P.O.A.D.P. PLAN
 for
 EISENHAUER / FRATT 19

**CITY OF SAN ANTONIO
POADP APPLICATION**

Re: Eisenhower – Fratt 19 Subdivision

POADP # 640

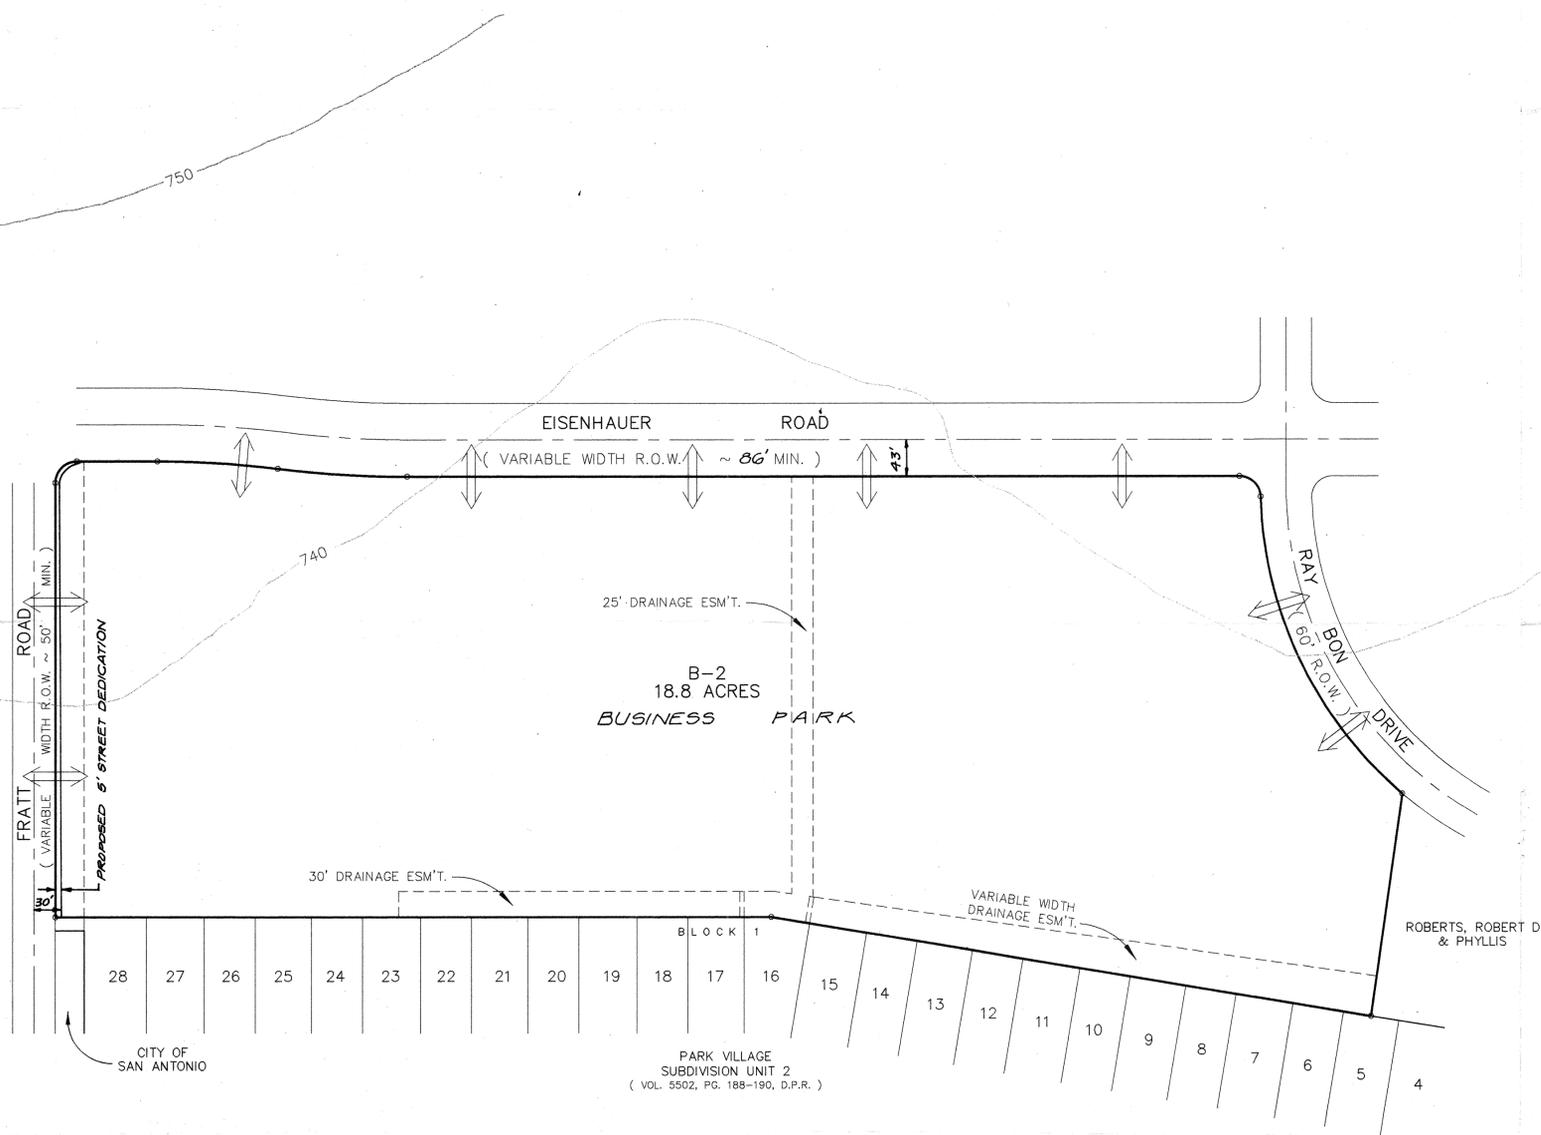
- Based on the topography, a Flood Plain Study and drainage review will probably be required during the platting process.
- According to the Major Thoroughfare Plan the Right of Way requirements for Fratt Road is 60', and Eisenhower Road requires a minimum of 86'.

- In consideration of public safety and convenience, excessive grades by reason of topography should be avoided in street layouts and arrangements.
- Access along Eisenhower Road, Ray Bon Drive and Fratt Road will be limited to two driveways each, with the understanding that the development would include shared access and internal circulation. Please note that fewer driveways on Ray Bon and on Fratt Road may be required at the time of Platting.

- This development will need to comply with tree preservation ordinance #85262. For information about these requirements you can contact Building Inspections at 207-7102.

- It will be expected that you will plat all of the property depicted in your POADP, to include: floodpains, drainage areas and open space.
- I would encourage you to work closely with the school district, so that they can plan accordingly.
